RF TEST REPORT

Applicant	Kizy Tracking SA
FCC ID	2AGPEWT2
Product	Tracker
Model	K-2
Report No.	R1903A0135-R2
Issue Date	April 26, 2019

K-2 (Report No: R1903A0135-R2) is a variant model of K-2 (Report No: RXA1712-0426RF01R2). Test values partial duplicated from Original for variant. GSM 850 was selected as the worst condition. There is only tested Radiates Spurious Emission of GSM 850 for variant in this report. The detailed product change description please refers to the ANNEX B.

K-2 Difference statement

1. Added 3 resistors to confirm the version,R31,R33,R34,

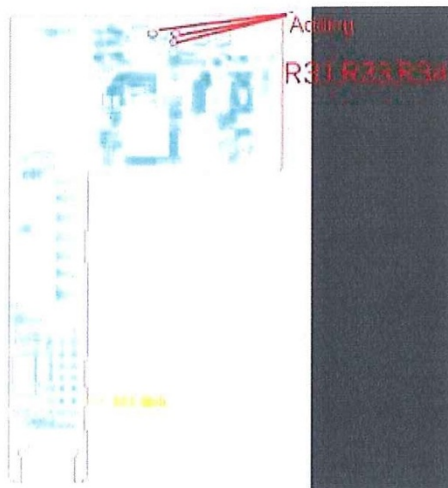
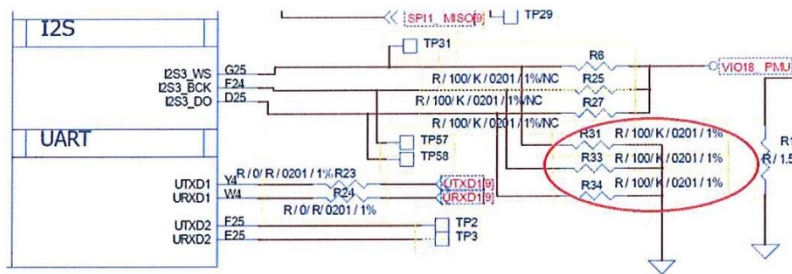
1	WT2N	Hardware Ver. Control	Add pull low resistance to check HW Ver. MTK U402 I2S3_WS(G25), I2S3_BCK(F24),I2S3_DO(D25), PCB version,PULL HIGH100KΩ,VIO18_PMU, with PULL LOW 100KΩ to GND Actually the pieces are: U402_I2S3_WS(G25),PULL LOW U402_I2S3_BCK(F24),PULL LOW U402_I2S3_DO(D25),PULL LOW
---	------	-----------------------	--

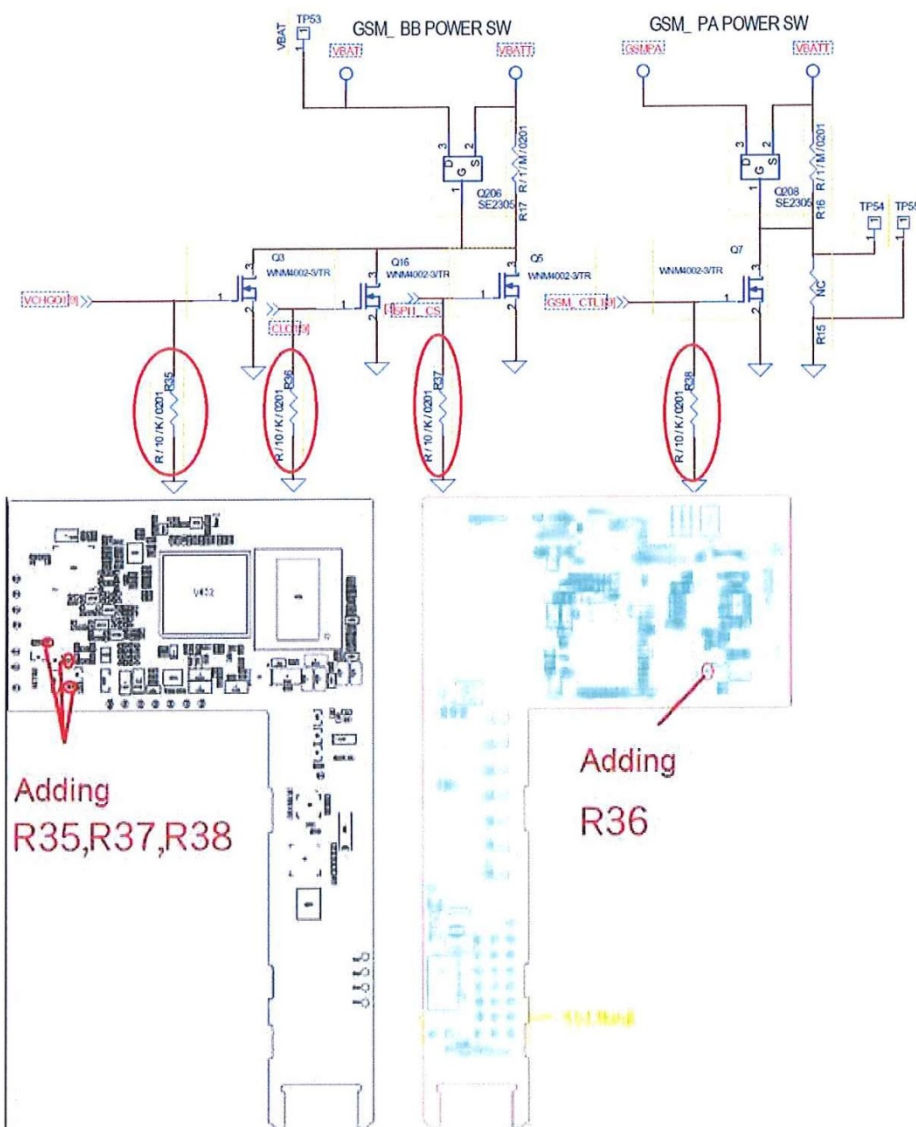
2	WT2N	Power Leakage When Off Switch	Add pull low resistance to shut down VBATT power Because it cannot be completely shut down, it must be 1.Q3' s G PIN parallel $10K\Omega$ to GND 2.Q160' s G PIN parallel $10K\Omega$ to GND 3.Q5' s G PIN parallel $10K\Omega$ to GND 4.Q7' s G PIN parallel $10K\Omega$ to GND
---	------	----------------------------------	---

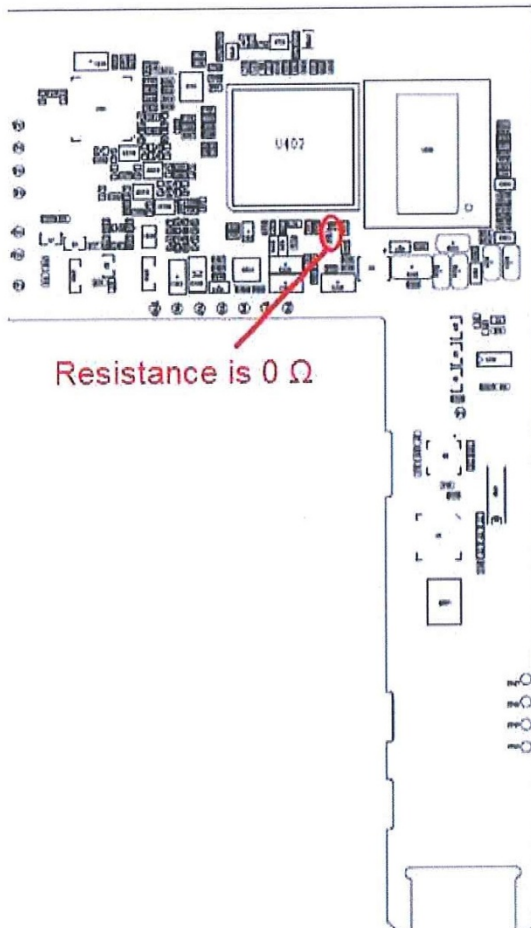
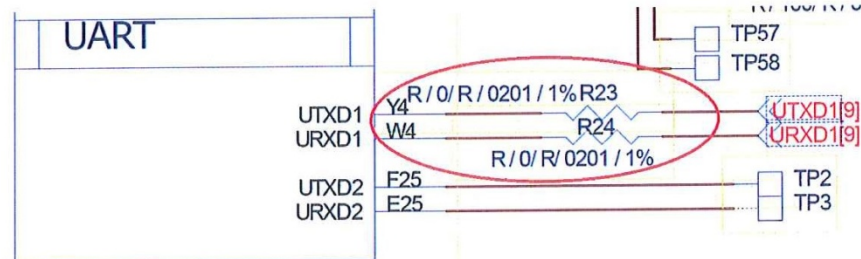
3	WT2N	UART Slew Rate	Resistance value change to 0Ω For UART R23 and R24 Change the resistance to 0Ω
---	------	----------------	---

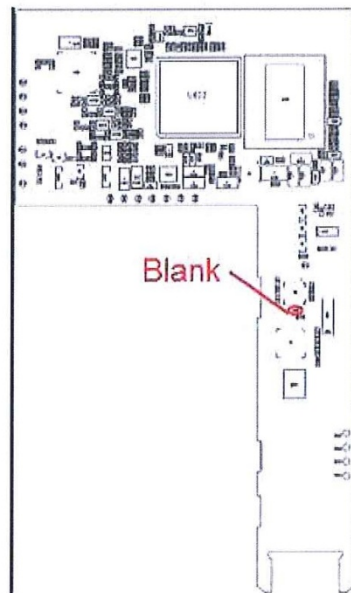
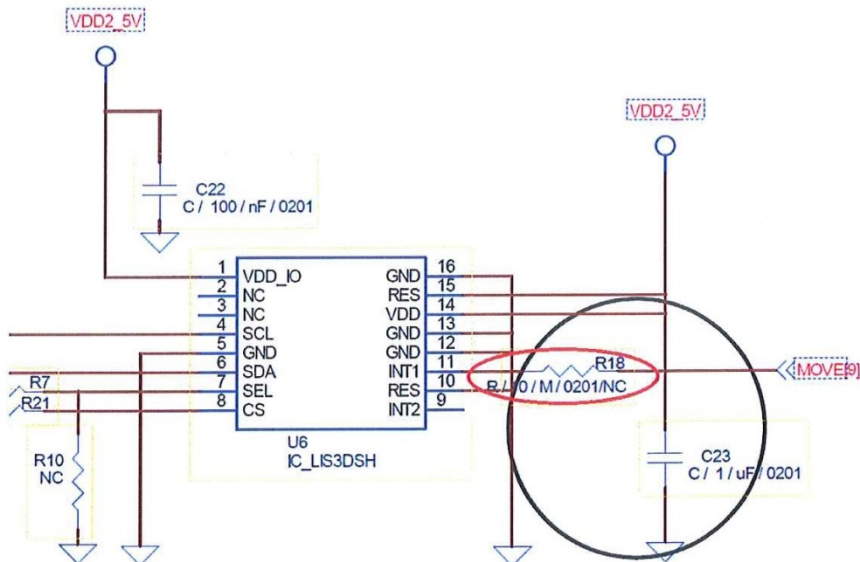
4	WT2N	Accelerometer malfunction	Take off R18
---	------	---------------------------	--------------

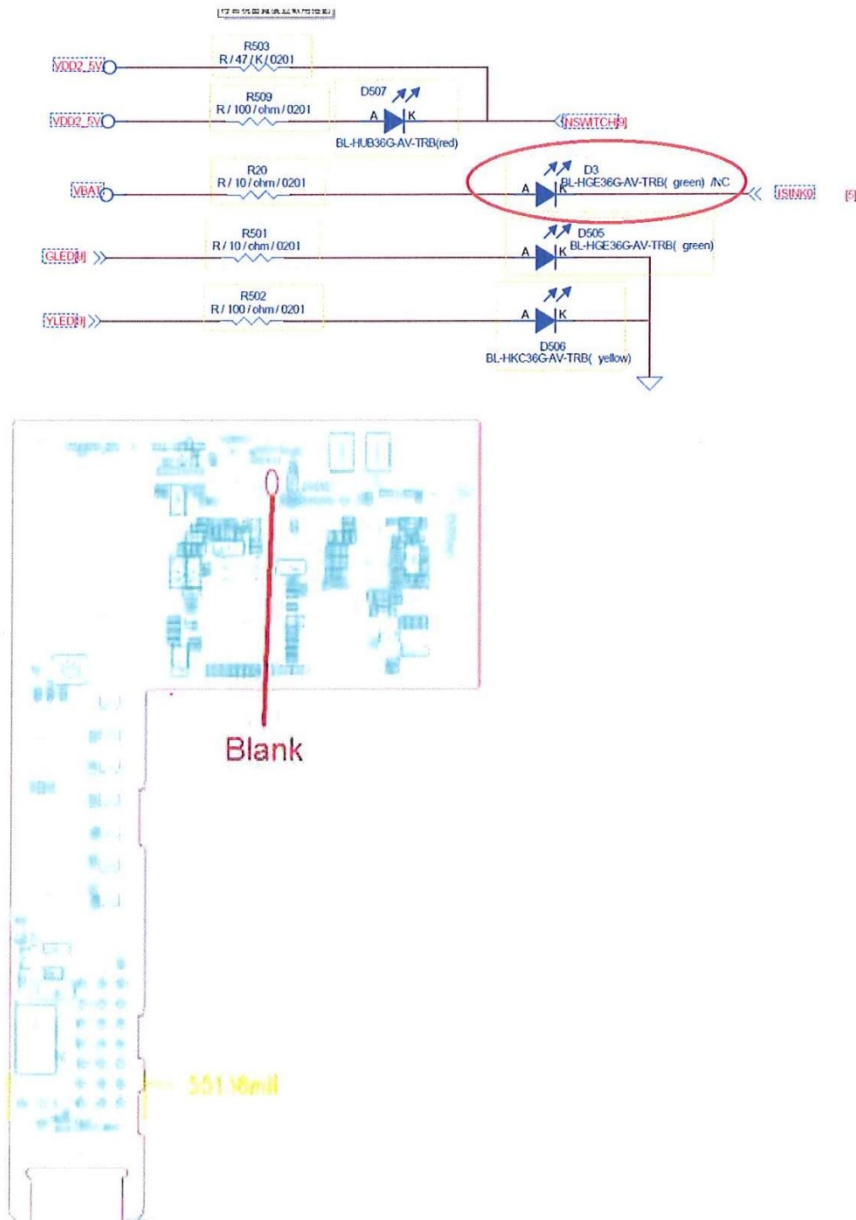
5	WT2N	4th LED removed	Take off D3
---	------	-----------------	-------------

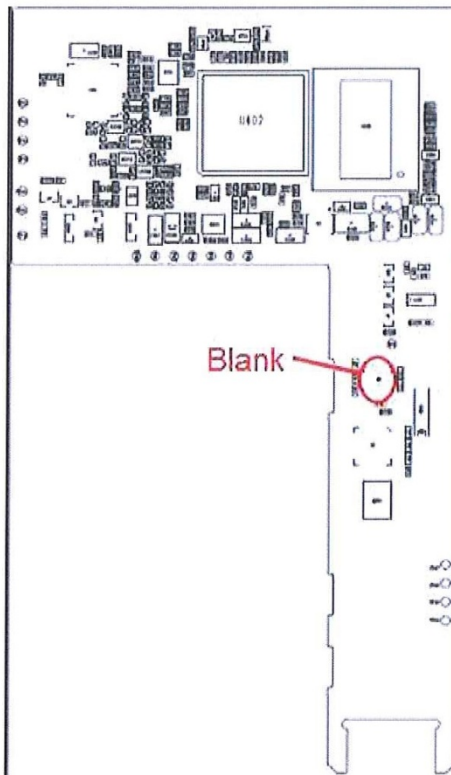
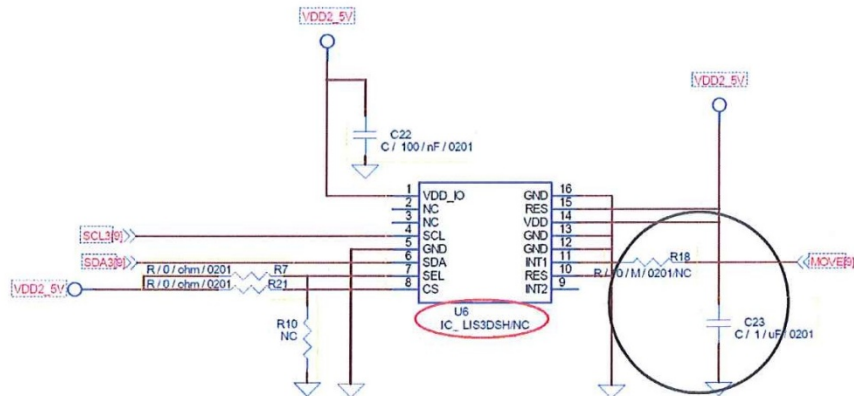
6	WT2N	Accelerometer removed	Take off U6
---	------	-----------------------	-------------
